8464373E01 REV P9 SCHEMATIC SHEET4

8464373E01 REV 0.V8 SCHEMATIC SHEET1 17/Nov/99

GSM TAICHI TRANCEIVER
P/N 8464373E01
SHEET 4 (LCD)

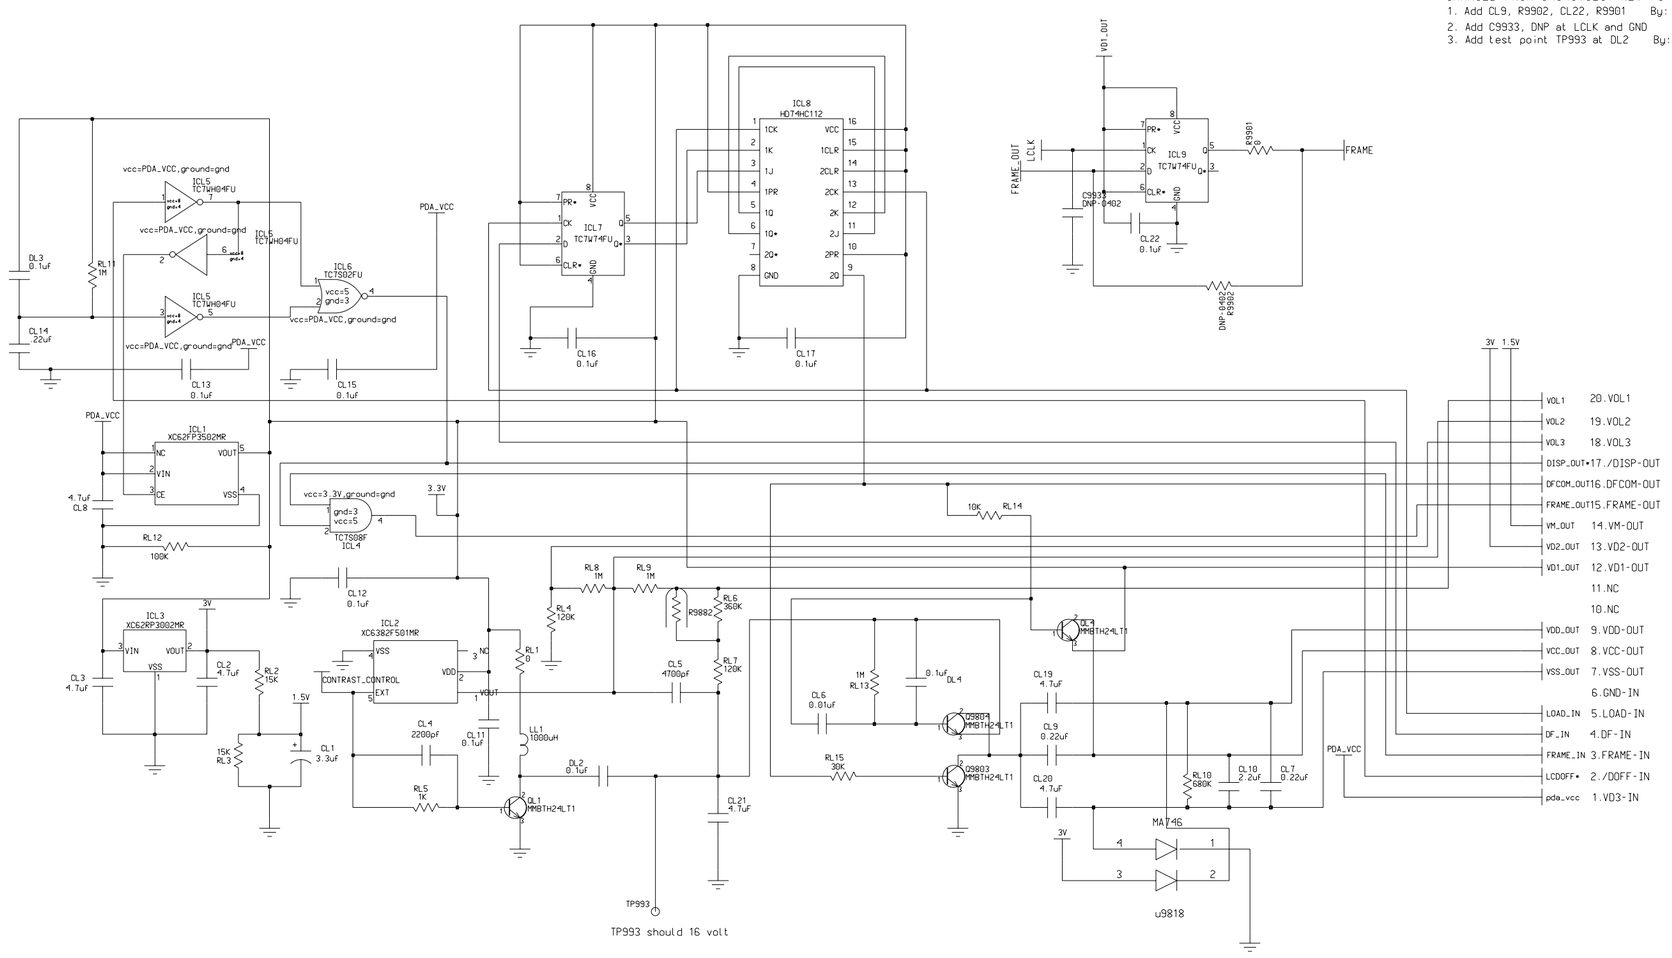
1. Change all parts to MOTOROLA Part No.
2. Remove R9870 since no Motorola P.N
3. Change ICL5 package to same with ICL7 package

1. Add CL9, R9902, CL22, R9901 By: CC Wang
2. Add C9933, DNP at LCLK and GND By: Bob Huo
3. Add test point TP993 at DL2 By: CC Wang
